Parcel 9, Phase 2 Revised Concept Plan Summary

I-195 Redevelopment District Commission Meeting
November 9, 2022

Revised Concept Plan Submission

Three stormwater design features are proposed:

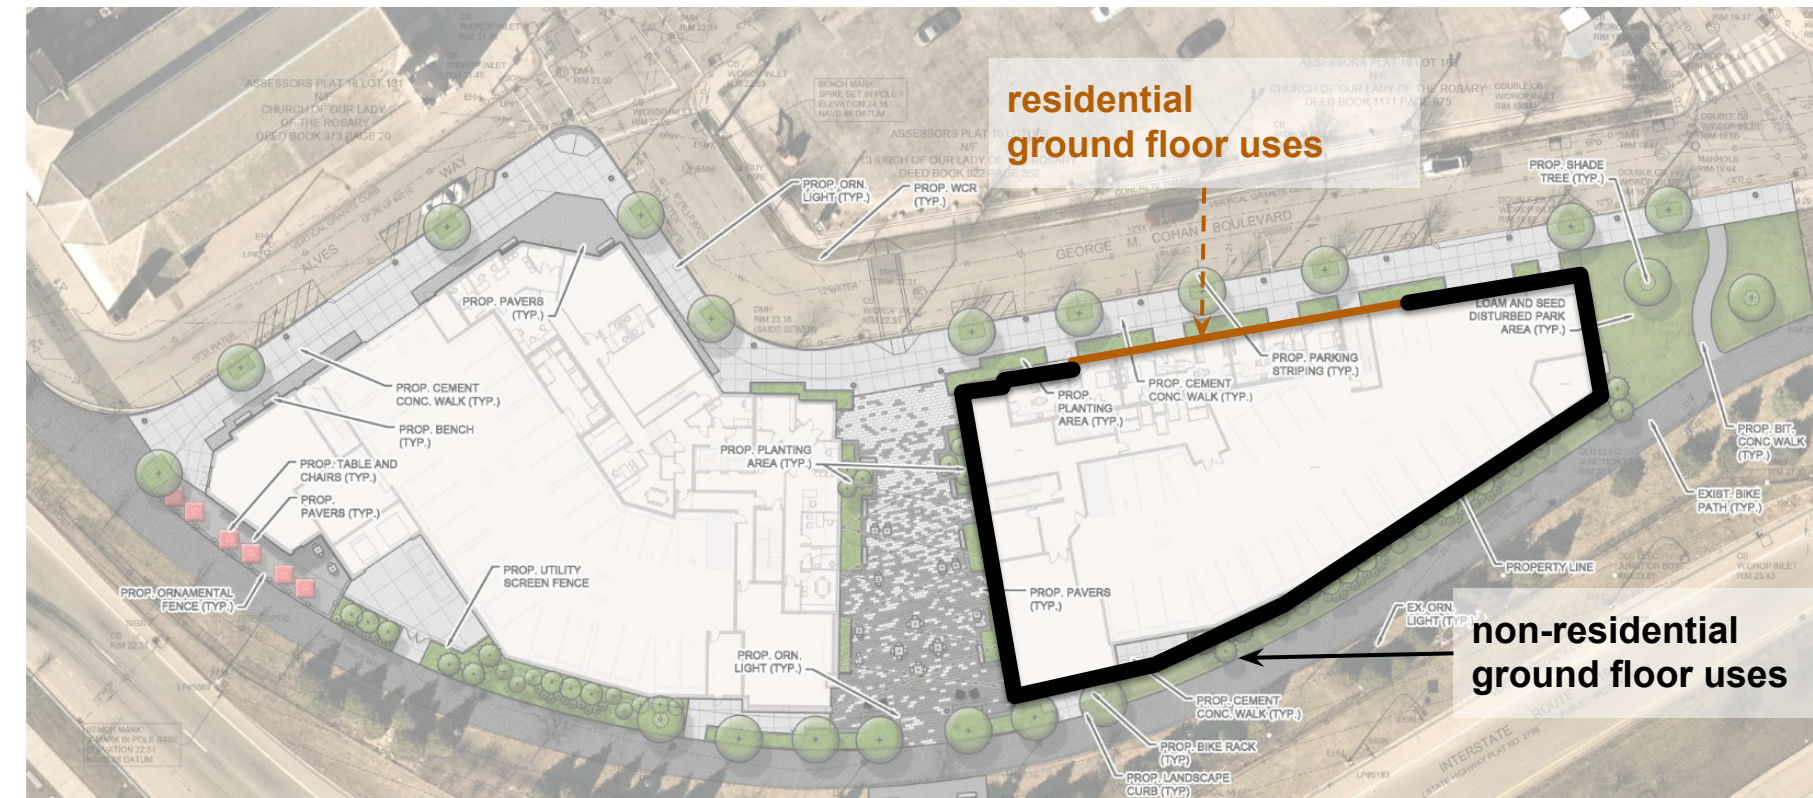
The design has incorporated features to treat stormwater for the entire site (Phases 1 + 2). The proposed stormwater design provides a solution which incorporates low impact development (LID) and green infrastructure (GI) stormwater best management practices (BMPs) to maintain or replicate pre-development hydrology by preventing, managing and treating runoff as close to its source as possible.

- Sand filter
- Tree filter
- Extensive green roof on the second-floor amenity Terrace

All three will be constructed during the Phase 1 West Building construction, then tied into Phase 2.
